MOE'S ON TEN REZONING LOCATION

PLANNING REVIEW

JZ22-27 with Rezoning 18.738

Rezoning Request from B-1 (Local Business) to B-3 (General Business)

SITE SURVEY

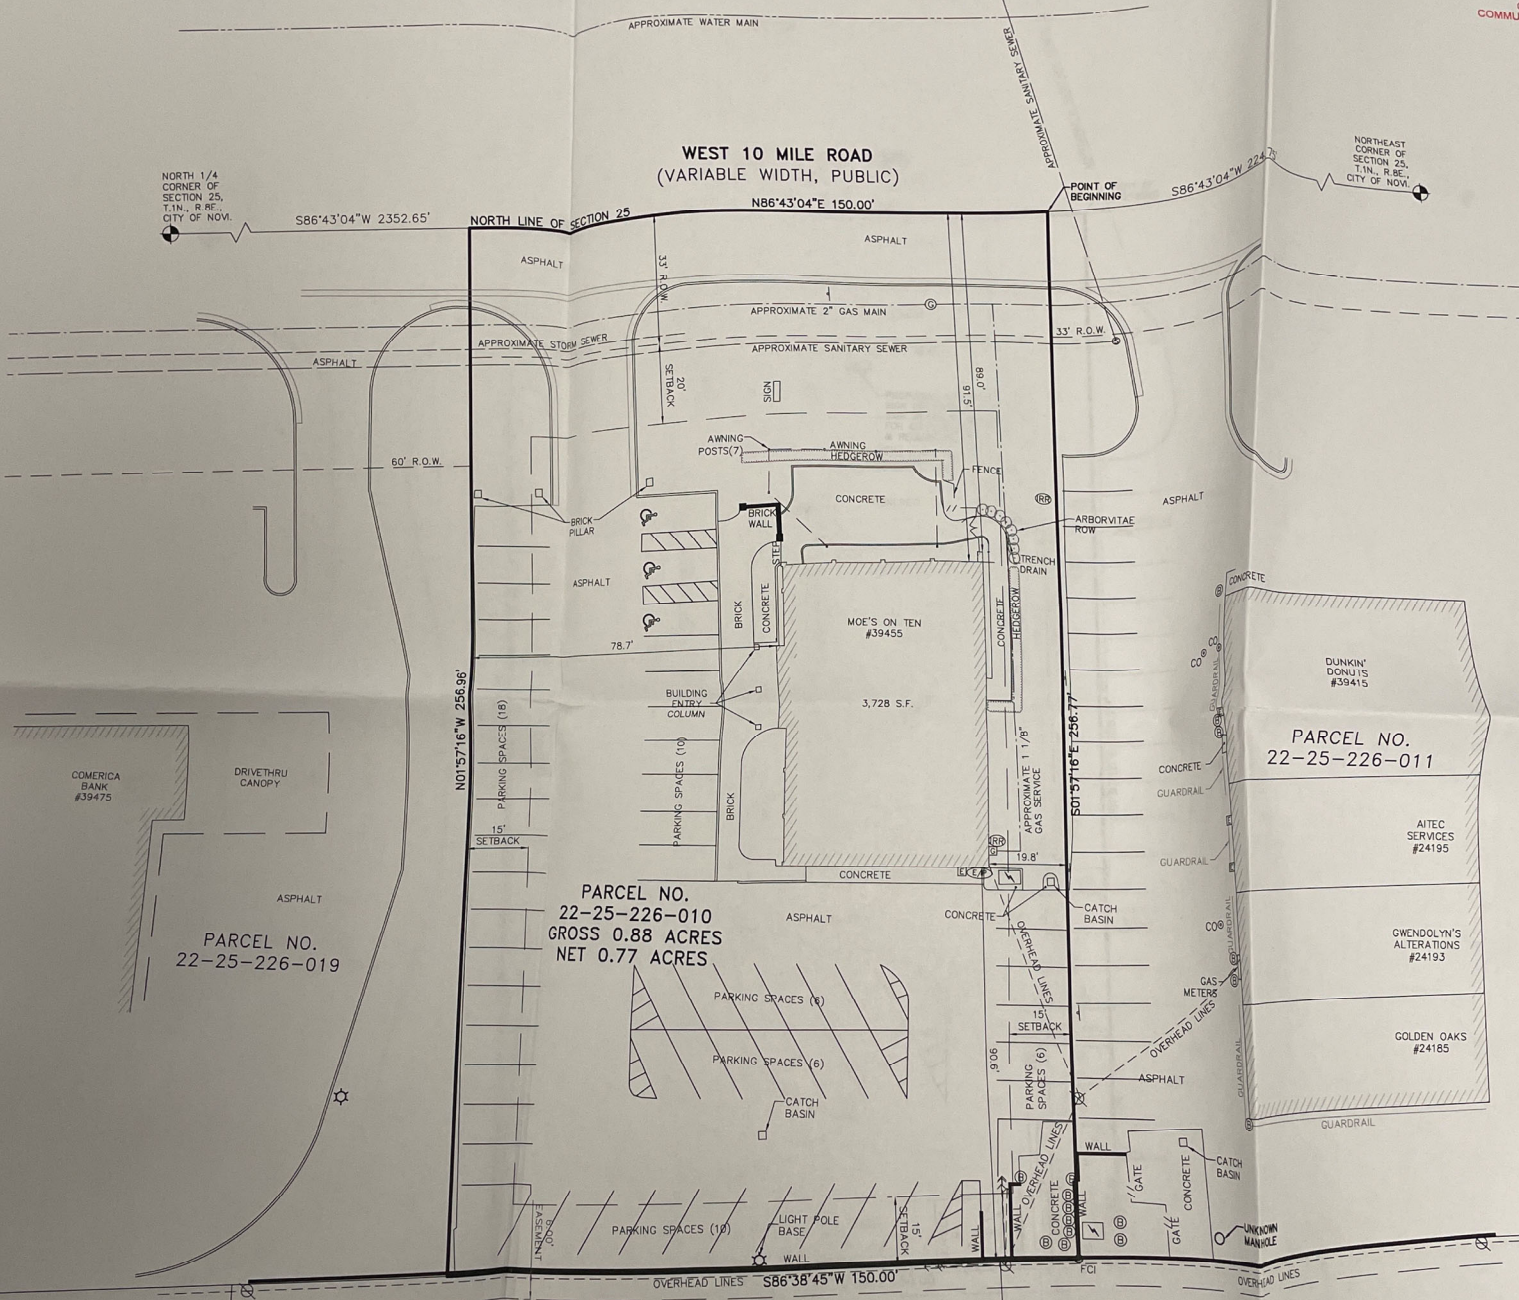
1. Site Survey: A survey of the site has been provided to staff. **If possible, please show the future right-of-way line and the location of the barrier free signage in the next submittal.**
2. Rezoning Traffic Study (RTS): The applicant has requested a waiver of the rezoning traffic study (RTS), which is supported by the City's Traffic Consultant as the site is not intended to change uses at this time.
